NTD-NRC-96-4626
DCP/NRC0451
Docket No.: STN-52-003

SUBJECT: WESTINGHOUSE RESPONSES TO NRC REQUESTS FOR ADDITIONAL
INFORMATION ON THE AP600

RAI's addressed in the January 19, 1996 submittal:

Figure 440.448-1 AP600 Passive Safety Systems Configuration

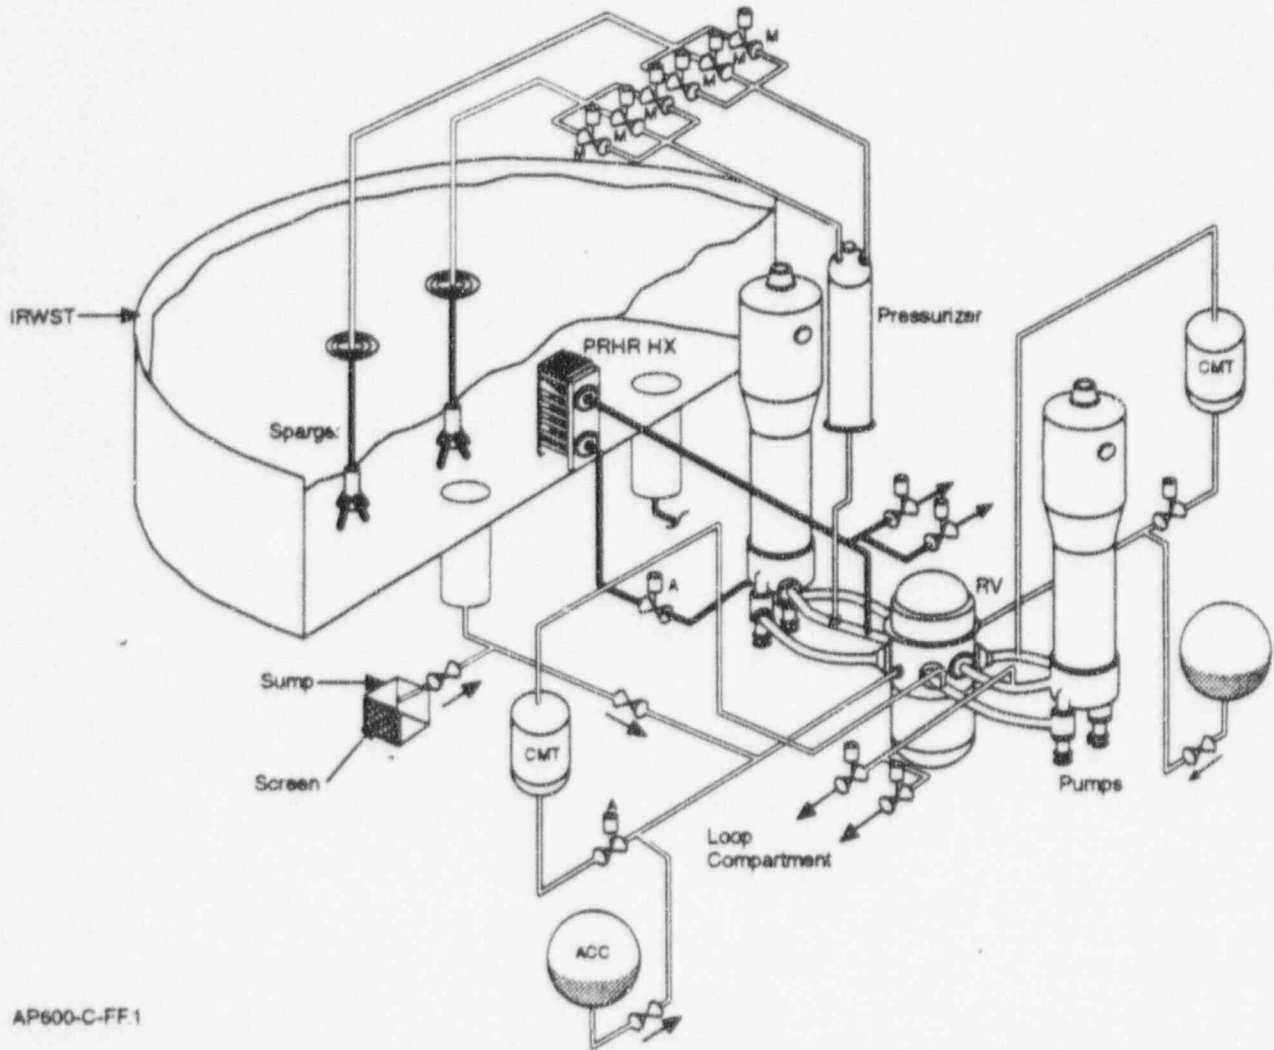
On page 3-3, it is stated that the AP600 plant system design is shown in Figure 1-1. This figure is missing from the document.

Attached please find a copy of Figure 440.448-1

Figure 440.479-1

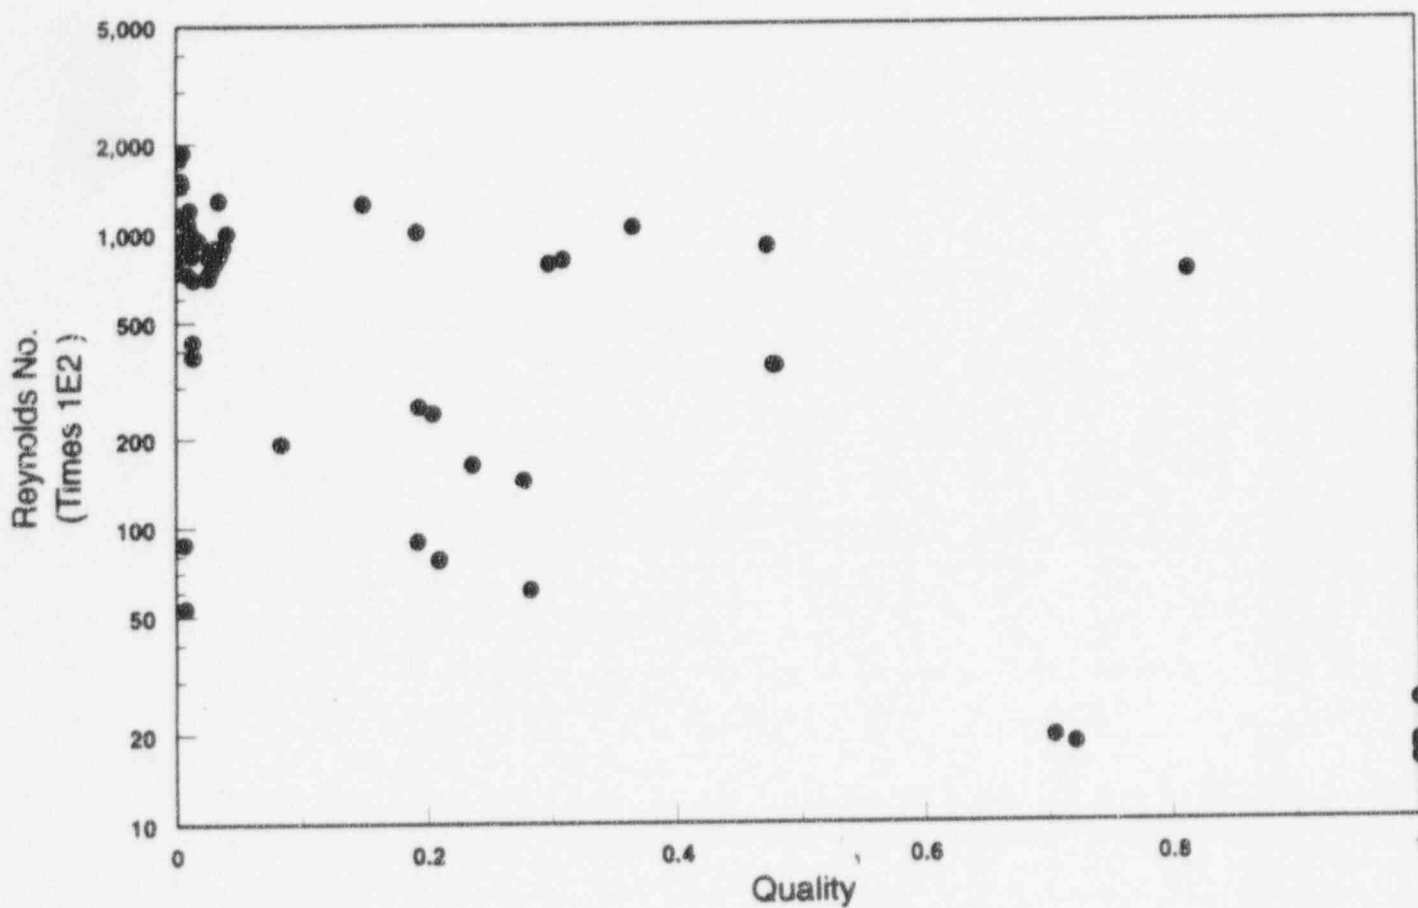
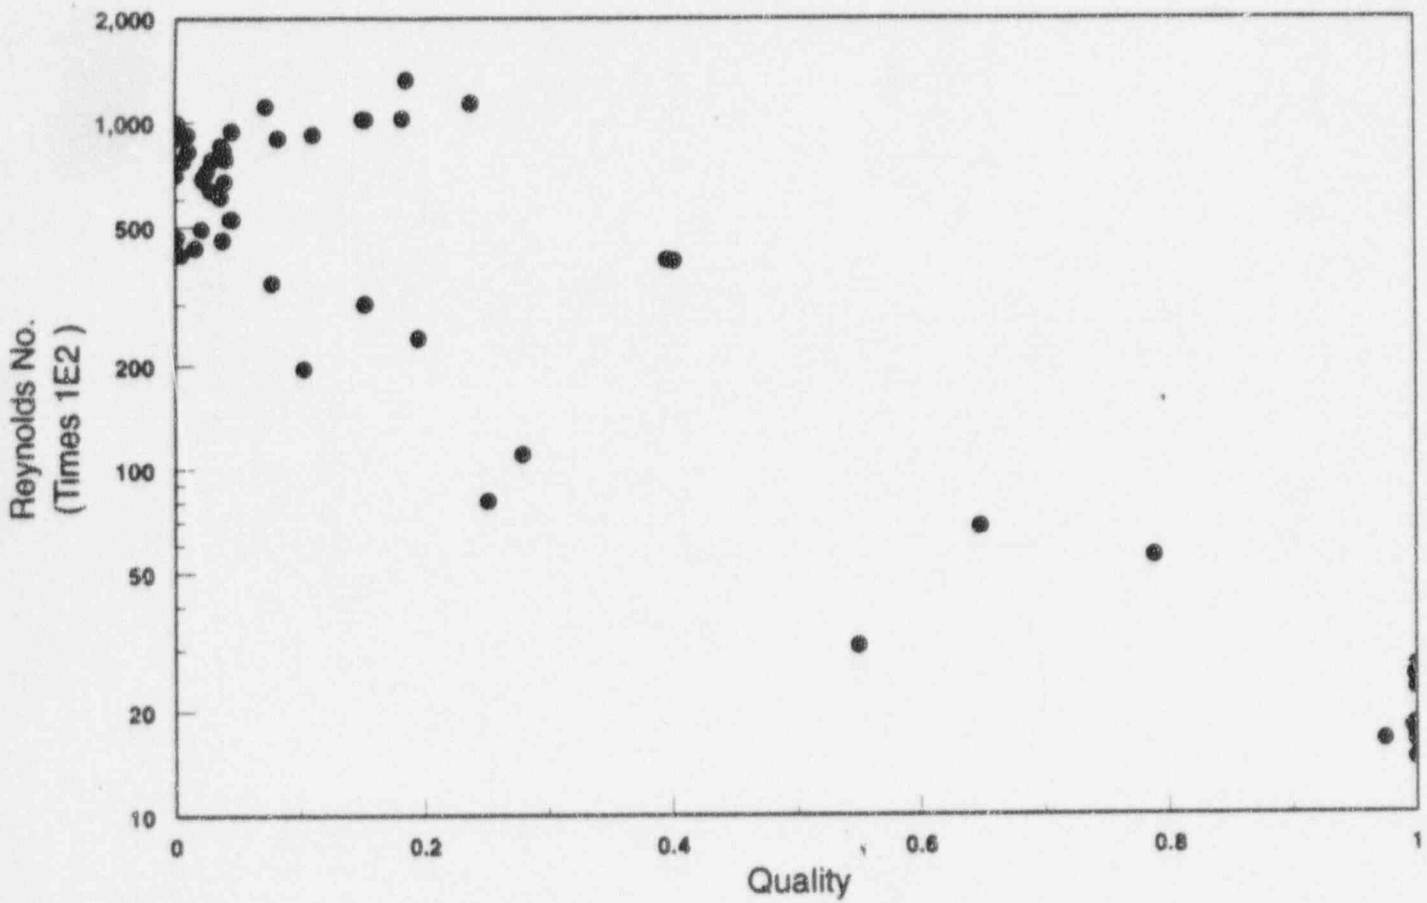
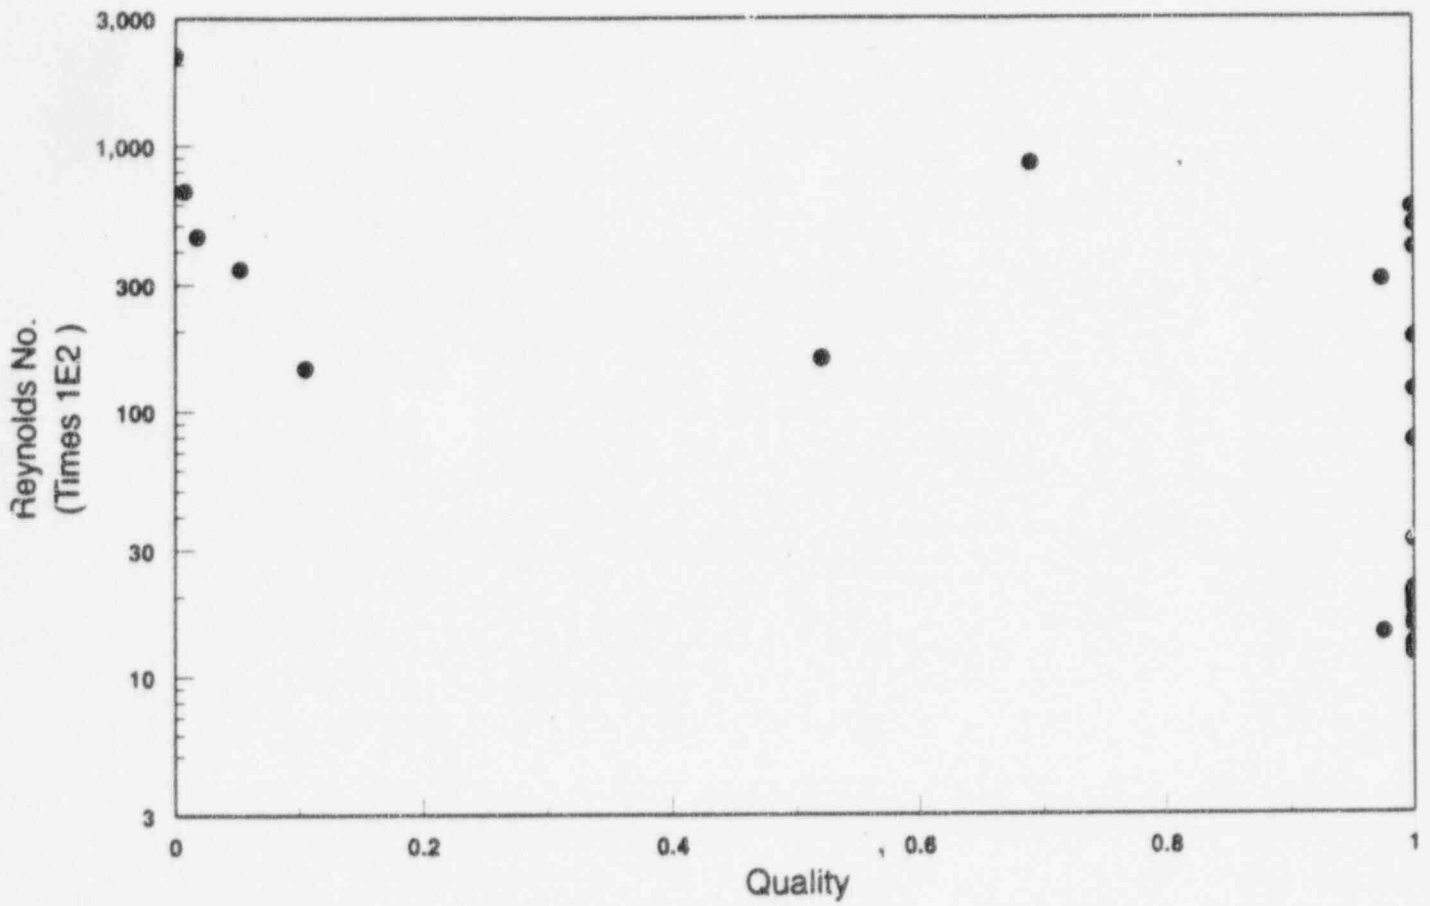
440.479 Provide a comparison of the NOTRUMP Shah condensation model prediction to condensation test data demonstrating applicability of the model to the range of conditions expected in AP600.

The two-phase mixture mass flow effects, in the Shah correlation, are captured by a liquid Reynolds number which is based on the total mixture flow being liquid. Figures 440.479-1 to 440.479-3 show the calculated liquid equivalent two-phase mixture Reynolds number for three small-break cases (a 1-inch, 2-inch and DEDVI break cases) plotted as a function of inlet quality. The liquid equivalent Reynolds number is calculated for the times when a two-phase mixture enters the PRHF, for each of these cases. The lower limit for the Reynolds number in the Shah correlation for pipes is 104 from Table 2, and the recommended lower limit is 350. All the points on Figures 440.479-1 to 440.479-3 are above the lower recommended limit of 350. While the correlation data base upper limit on the Reynolds number is 62,900 for pipes; there is no recommended Reynolds number upper limit in Table 2. There are a number of calculated Reynolds points from NOTRUMP which are higher than the data range used to test the correlation, however, if the upper limit of the mass flux in Table 2 is used to calculate a Reynolds number the upper limit is 286,000.0 which exceeds the values calculated by NOTRUMP for the PRHR. Therefore, the Shah correlation is appropriate for modeling condensation in the PRHR and steam generator tubes.
